Client: VAMC Providence, Rhode Island
830 Chalkstone Ave
Providence, RI 02908

Report: Fire Barrier Wall - Large Opening
VA 241-15-C-0127
PO 650-C58125

Providence VA Medical Center - Fire Barrier Wall Large Opening (Holes) Report

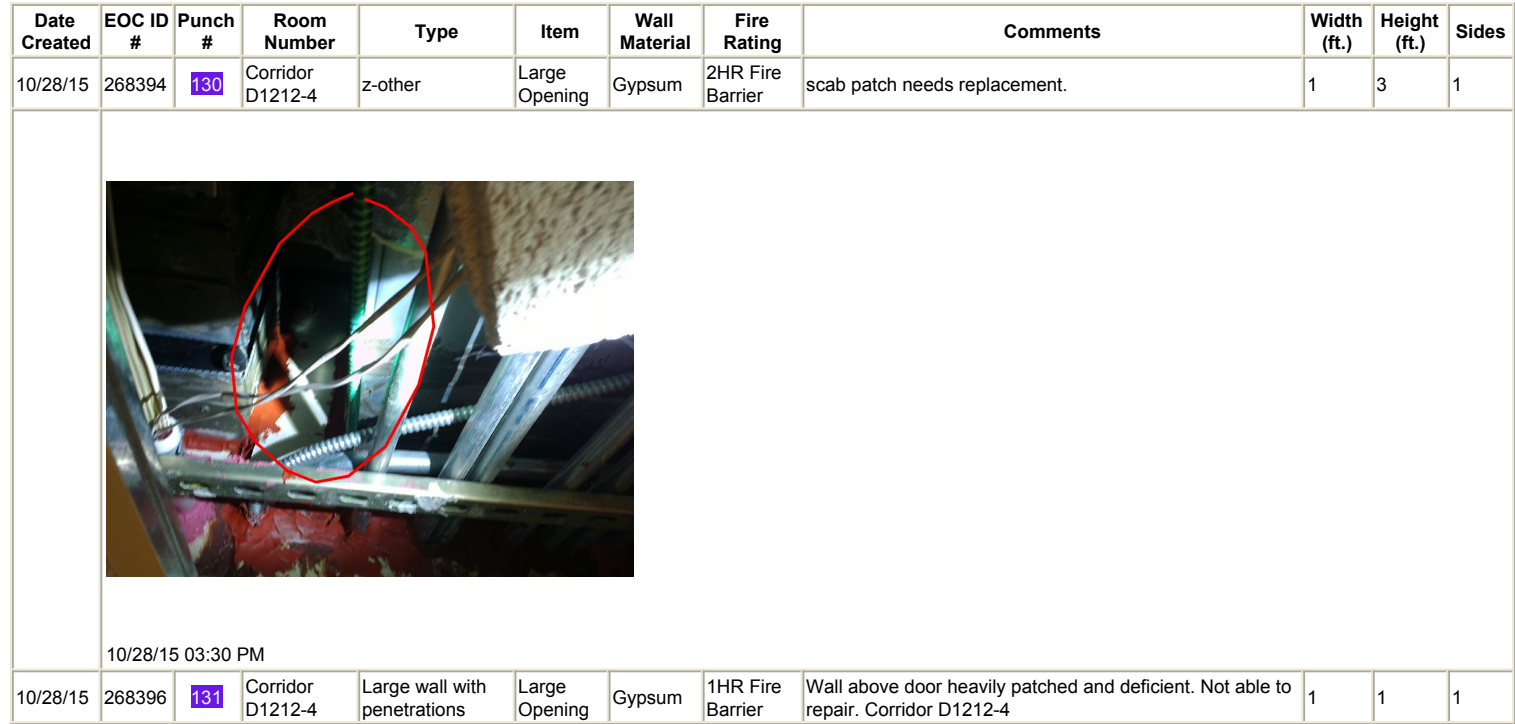
Date Created	EOC ID #	Punch #	Room Number	Type	Item	Wall Material	Fire Rating	Comments	Width (ft.)	Height (ft.)	Sides
 <p>10/27/15 01:12 PM</p>											
10/27/15	266839	109	D013	Large wall with penetrations	Large Opening	Gypsum	1HR Fire Barrier	scab patch with cable bundle.	1	2	1
 <p>10/27/15 01:21 PM</p>											
10/27/15	266840	110	D012	Large wall with penetrations	Large Opening	Gypsum	1HR Fire Barrier	Gypsum board seams need to mud and taped.	2	2	1
 <p>10/27/15 01:33 PM</p>											
10/27/15	266841	111	Office D012	z-other	Large Opening	Gypsum	1HR Fire Barrier	Gypsum board seams need to mud and taped.	1	1	1

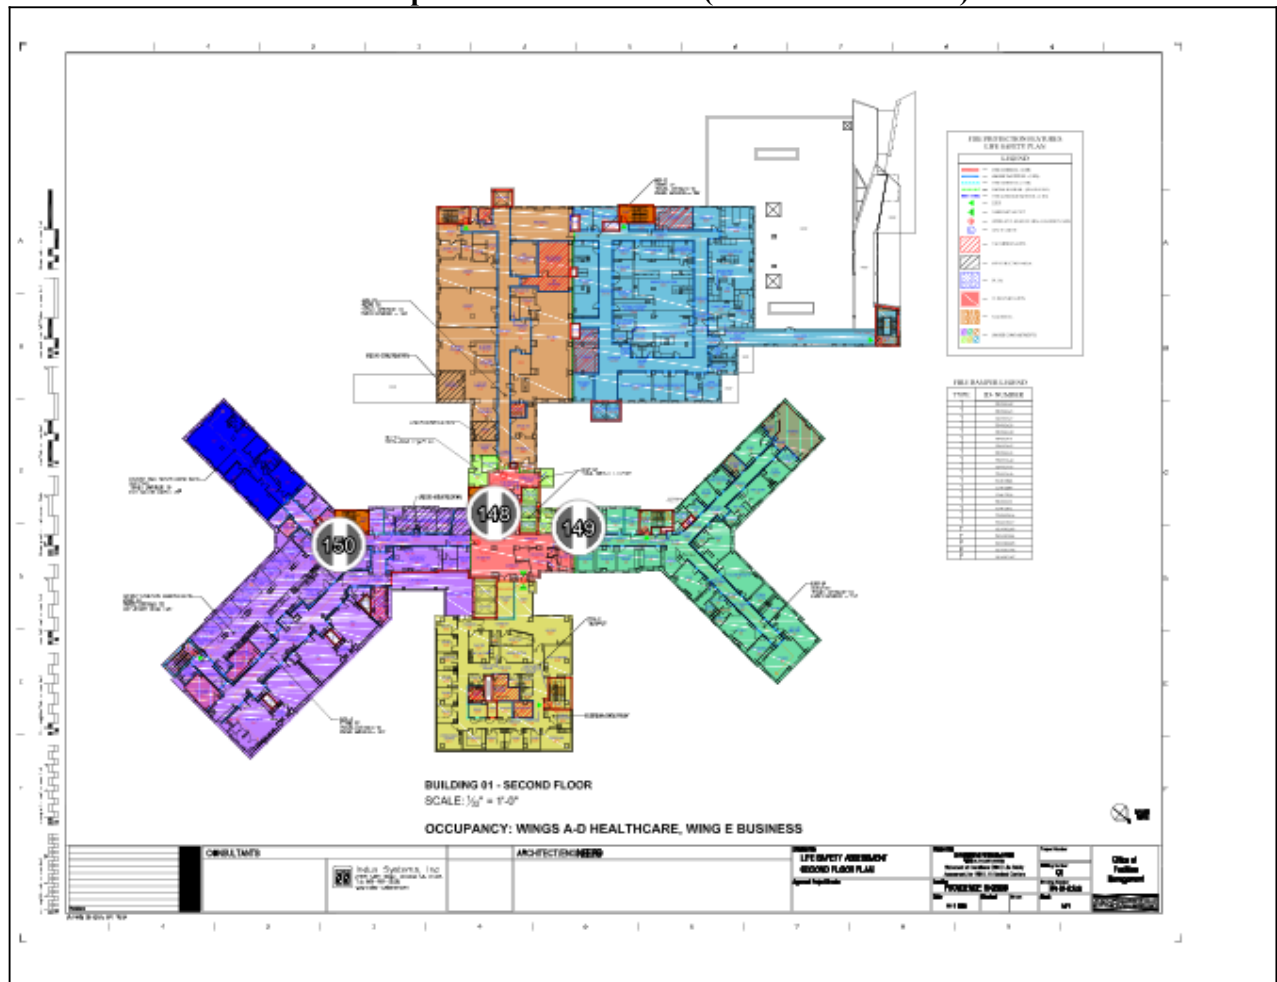
Date Created	EOC ID #	Punch #	Room Number	Type	Item	Wall Material	Fire Rating	Comments	Width (ft.)	Height (ft.)	Sides
 <p>4/5/16 02:49 PM</p>											
4/5/16	307404	221	Mechanical room D009	z-other	Large Opening	Gypsum	1HR Fire Barrier	1ft x 1ft Scab Patch	1	1	1
 <p>4/5/16 02:50 PM</p>											
4/5/16	307405	222	Mechanical Room D009	z-other	Large Opening	Gypsum	1HR Fire Barrier	1ft x 1ft Scab Patch	1	1	1
 <p>4/5/16 02:53 PM</p>											
4/5/16	307406	223	Mechanical Room D009	z-other	Large Opening	Gypsum	1HR Fire Barrier	1ft x 1ft Scab Patch	1	1	1

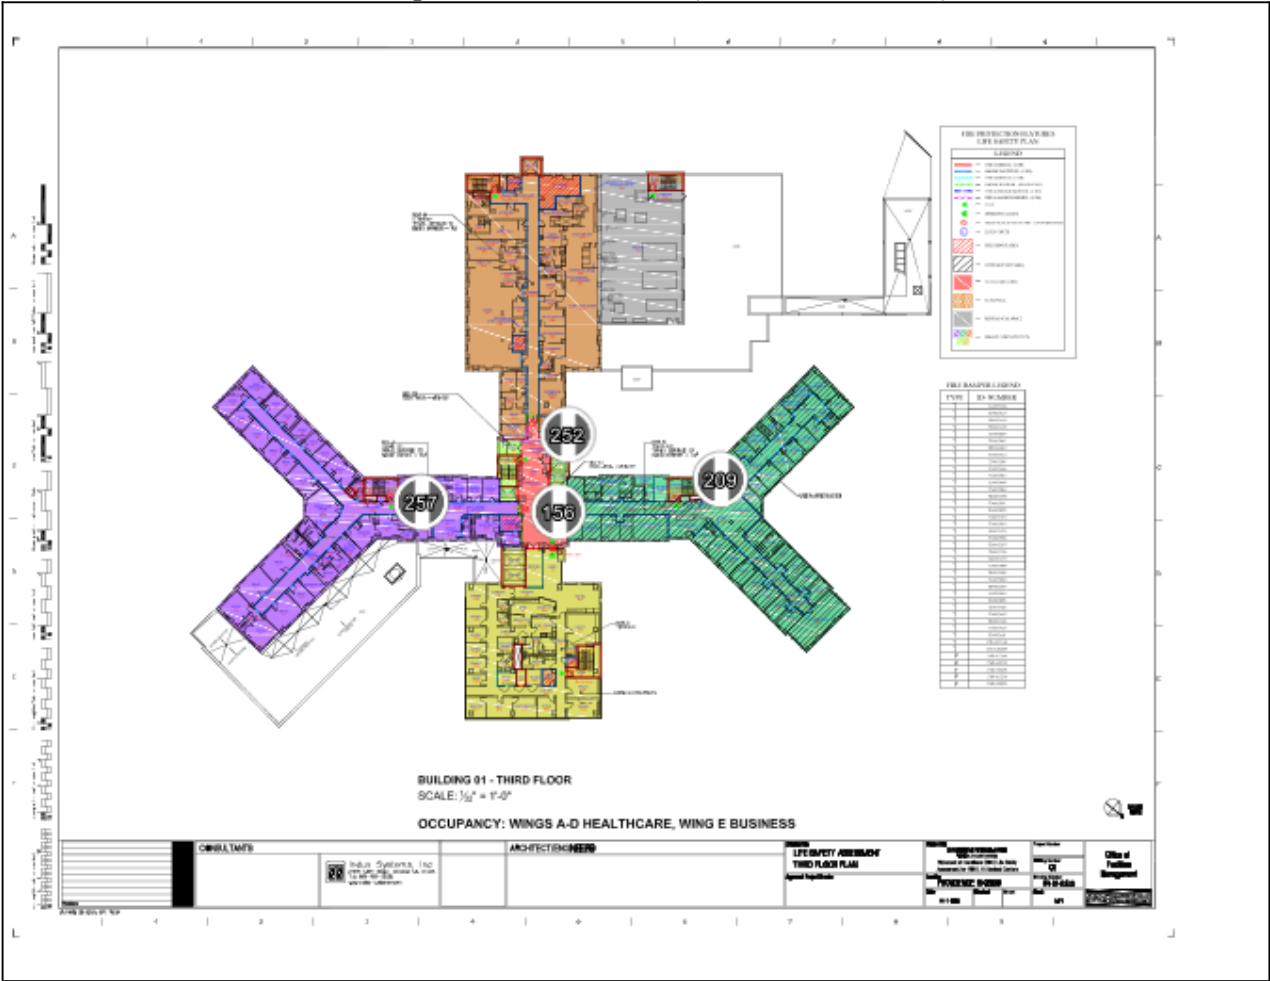
Date Created	EOC ID #	Punch #	Room Number	Type	Item	Wall Material	Fire Rating	Comments	Width (ft.)	Height (ft.)	Sides
<div>   </div> <div> <div>10/28/15 03:53 PM</div> <div>10/28/15 03:53 PM</div> </div>											
10/29/15	268451	146	D1013	Sections of walls missing	Large Opening	Gypsum	2HR Fire Barrier	Wall needs demo and rebuilt to restore fire rating. Room D1013	3	2	1
<div>  </div> <div>10/29/15 11:21 AM</div>											
10/29/15	268482	147	1-L-C5 Dbl Door 1C2A	No access due to mechanicals	Large Opening	Concrete	30min Smoke Barrier	Room on PFI 1-192. No access to rated barrier deficiencies due to the amount of mechanicals i.e. duct work, pipe, and or conduit etc. in the way. 1-L-C5 Dbl Door 1C2A	1	1	1
<div>   </div> <div> <div>10/29/15 12:46 PM</div> <div>11/6/15 12:07 PM</div> </div>											
11/2/15	269408	169	House keeping D152	Sections of walls missing	Large Opening	Gypsum	30min Smoke Barrier	Drywall is scabbed together. Needs to be demoed and rebuilt correctly to restore fire rating. Limited access due to mechanicals	4	3	1

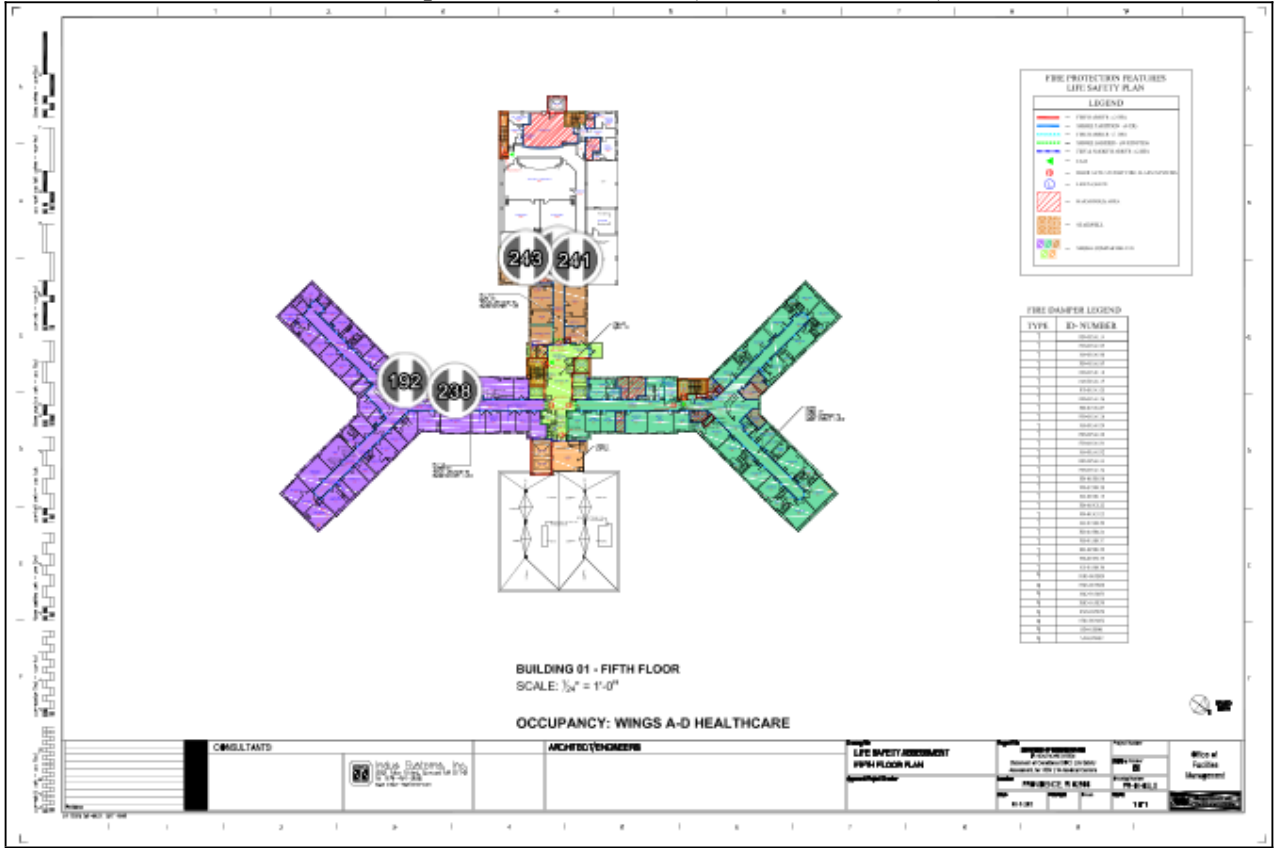
Date Created	EOC ID #	Punch #	Room Number	Type	Item	Wall Material	Fire Rating	Comments	Width (ft.)	Height (ft.)	Sides
10/30/15	268574	148	Elevator Lobby L-2	Sections of walls missing	Large Opening	Concrete	2HR Fire Barrier	Room on PFI 1-259. Non rated wall. Misc. penetrations, conduit and copper pipe. Room L-2	3	1	1
 <p>10/30/15 09:38 AM</p>											
10/30/15	268619	149	Radiologist Office 259	Large wall with penetrations	Large Opening	Gypsum	1HR Fire Barrier	Pipe needs protected on both sides.	1	1	2
  <p>10/30/15 10:39 AM 10/30/15 10:40 AM</p>											
10/30/15	268624	150	Soiled and O2 215B	Sections of walls missing	Large Opening	Gypsum	1HR Fire Barrier	Gypsum board missing. Metal studs in place. Top of wall joint will be needed also.	3	3	1
 <p>10/30/15 12:10 PM</p>

2016.4.April / 03. Third Floor (3 3rd Floor 102015) -

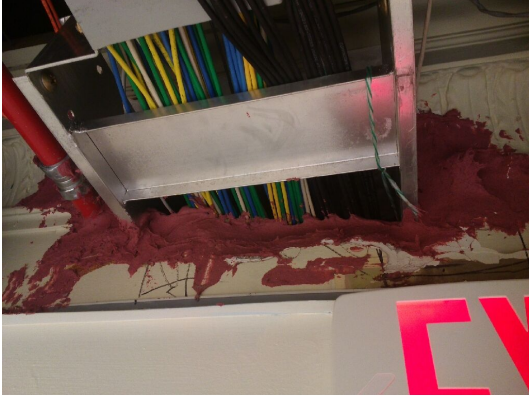
Date Created	EOC ID #	Punch #	Room Number	Type	Item	Wall Material	Fire Rating	Comments	Width (ft.)	Height (ft.)	Sides
10/30/15	268684	156	Lobby space	Large wall with penetrations	Large Opening	Concrete	30min Smoke Barrier	Wire lath and scratch coat is deficient and needs to be removed and protected properly. Misc penetrations.	25	1	1
<div></div> <p>10/30/15 02:09 PM</p>											
11/12/15	271617	209	Office 366	Sections of walls missing	Large Opening	Concrete	2HR Fire Barrier	Room on PFI. No PFI # listed. Part of 3-B renovation. General Contractor responsibility. Room 366	1	1	1

2016.4.April / 05. Fifth Floor (5 5th Floor 102015) -

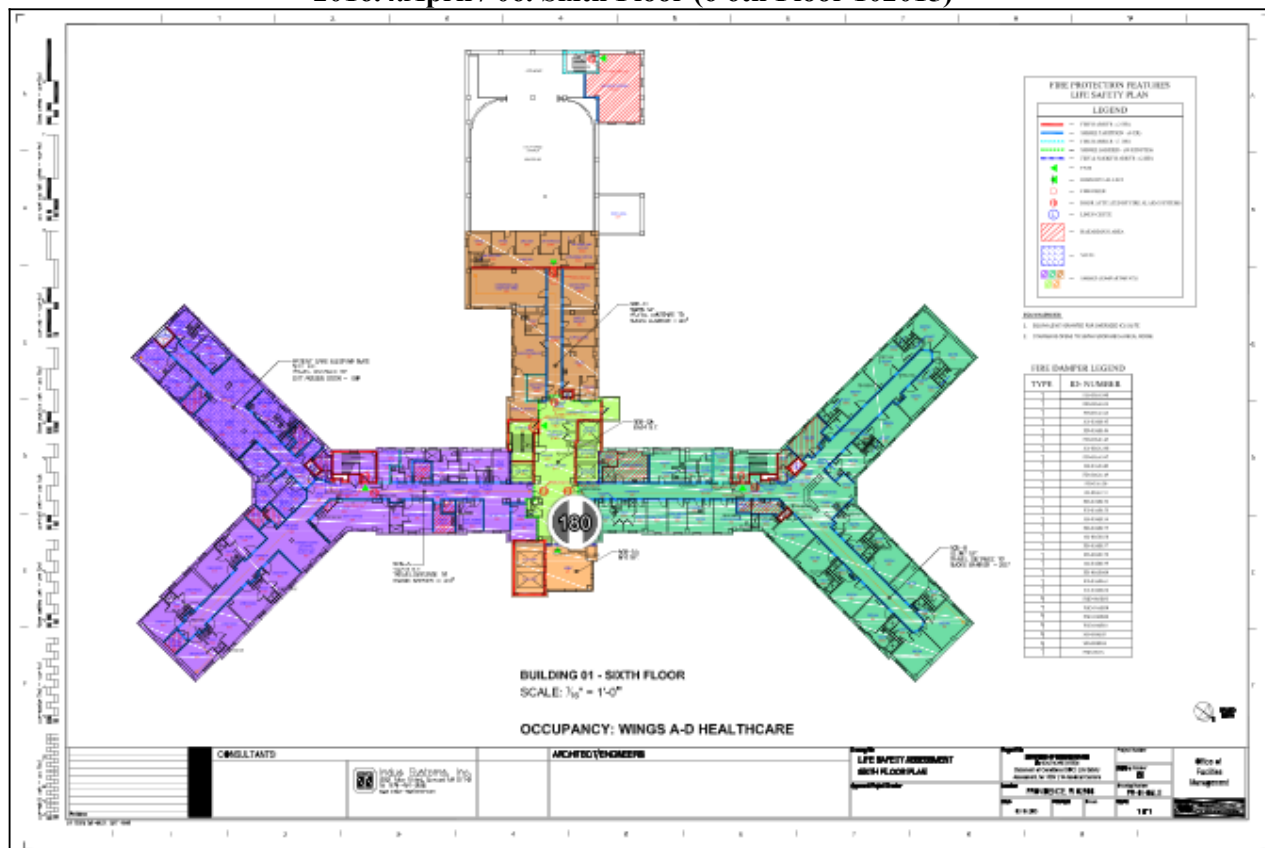
Date Created	EOC ID #	Punch #	Room Number	Type	Item	Wall Material	Fire Rating	Comments	Width (ft.)	Height (ft.)	Sides
11/10/15	271545	192	Closet 536B	Sections of walls missing	Large Opening	Gypsum	1HR Fire Barrier	Room on PFI 1-080. Non rated ceiling. Drywall ceiling is not rated. Concrete floor slab is the rated barrier. Penetrations are to be corrected from the top side of floor slab. Room 536B	1	1	1
<div></div> <p>11/10/15 01:01 PM</p>											
11/10/15	271548	195	Corridor 5CA-2	Sections of walls missing	Large Opening	Gypsum	2HR Fire Barrier	Room on PF11-093. Cable Tray needs protected. Room 5CA-2	2	1	2

2016.4.April / 06. Sixth Floor (6 6th Floor 102015) -

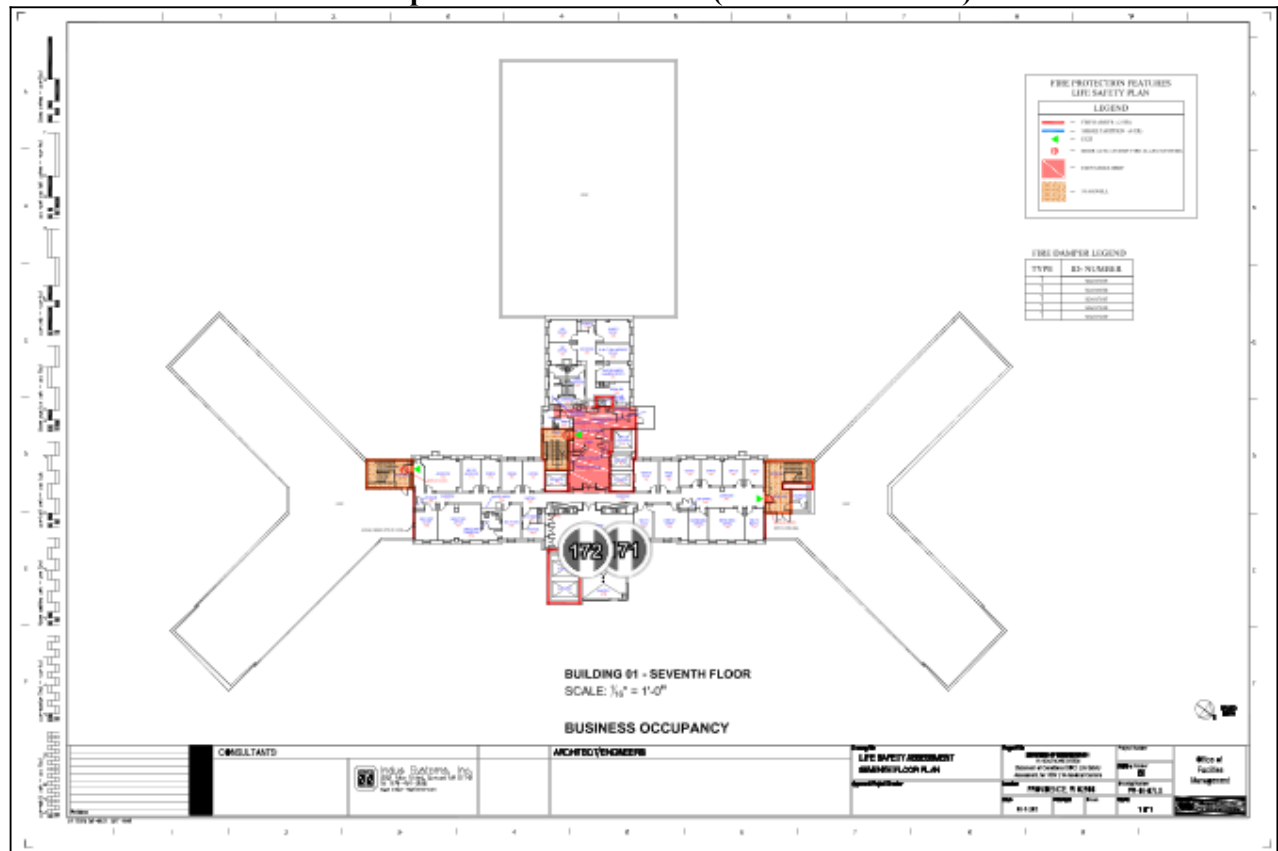
Date Created	EOC ID #	Punch #	Room Number	Type	Item	Wall Material	Fire Rating	Comments	Width (ft.)	Height (ft.)	Sides
11/6/15	269891	180	Surgical Residence Office 698	Sections of walls missing	Large Opening	Gypsum	30min Smoke Barrier	Room on PFI. No PFI # listed. Room 698	2	3	2

2016.4.April / 07. Seventh Floor (7 7th Floor 102015) -

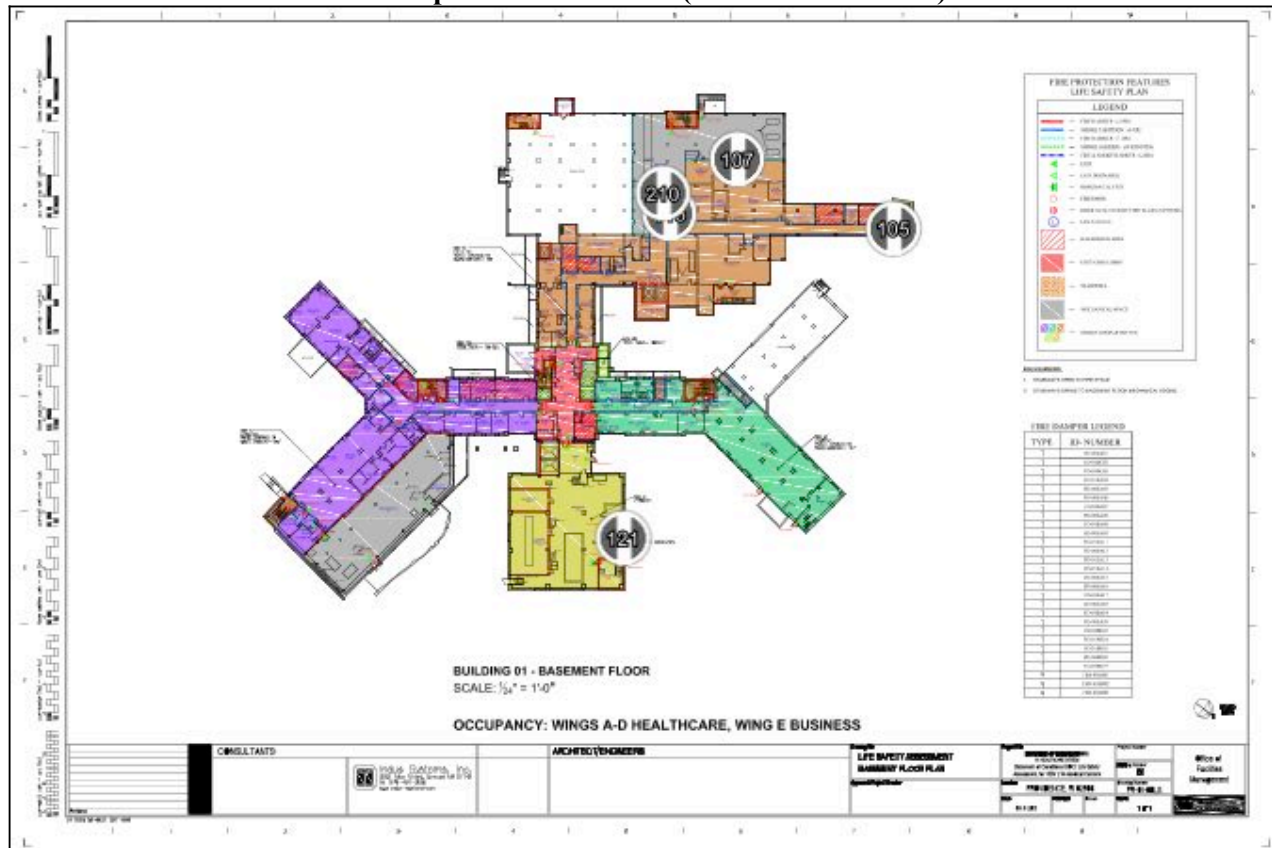
Date Created	EOC ID #	Punch #	Room Number	Type	Item	Wall Material	Fire Rating	Comments	Width (ft.)	Height (ft.)	Sides
11/2/15	269667	171	Conference Room 703	z-other	Large Opening	Gypsum	2HR Fire Barrier	Opening with blue board insulation. Insulation is an unrated material and needs to be removed. Opening needs to be replaced with gypsum and penetration protected.	2	2	1
 <p>11/2/15 04:09 PM</p>											
11/2/15	269668	172	Conference Room 703	z-other	Large Opening	Gypsum	2HR Fire Barrier	Section of wall missing and needs to be protected.	2	2	1
 <p>11/2/15 04:09 PM</p>

2016.4.April / 00. Basement (0 Basement 102015) -

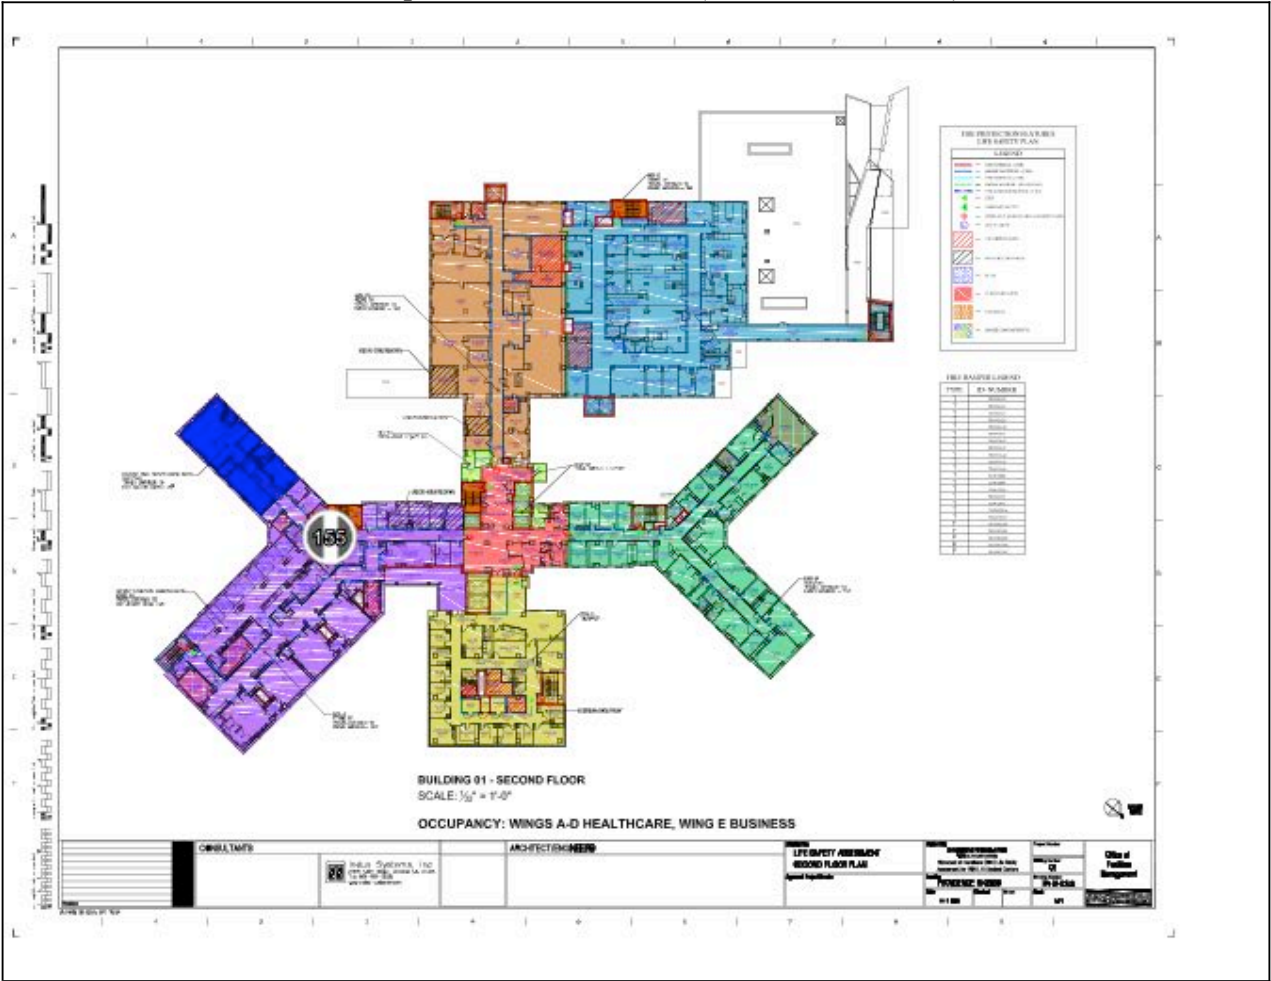
Date Created	EOC ID #	Punch #	Room Number	Type	Item	Wall Material	Fire Rating	Comments	Width (ft.)	Length (ft.)
10/27/15	266848	105	Stair G	Joints	Large Opening	Gypsum	1HR Fire Barrier	Gap between monokoted steel beam and wall needs to be protected.	.5	6
 <p>10/27/15 11:50 AM</p>										
10/27/15	266837	107	D009	Joints	Large Opening	Gypsum	1HR Fire Barrier	Joint is tight.	.5	100
